## MAN B&W Diesel A/S

No.: SL88-235/OES April 1988

## **Service Letter**

Chemical Attack of Flexible Hose Connections of the Type AEROQUIP FC350 Caused by the Decreasing Quality of HFO

FLEXIBLE HOSE - FUEL OIL

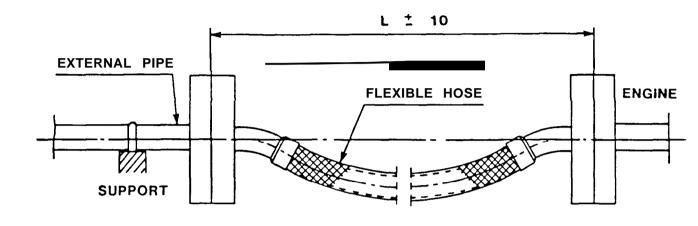
Furthermore, leakage of fuel oil from the flexible hose connections has been revealed due to in-accurate mounting. As a precaution, we recommend to check that the hose connections comply with the instructions on the enclosed technical information. (316-S1/614-S1).

The internal lenght "L" between the flanges must be in accordance with the actual type of the hose in the table.

The axis of flanges must coinside within  $\frac{1}{2}$  10 mm.

The hose must be mounted without any twist.

The external pipe connection to the flexible hose has to be rigidly fixed.

Abrasion from adjacent structures, moving parts or other hoses must be advoided.

The flexible hose must be mounted visible above floor level.
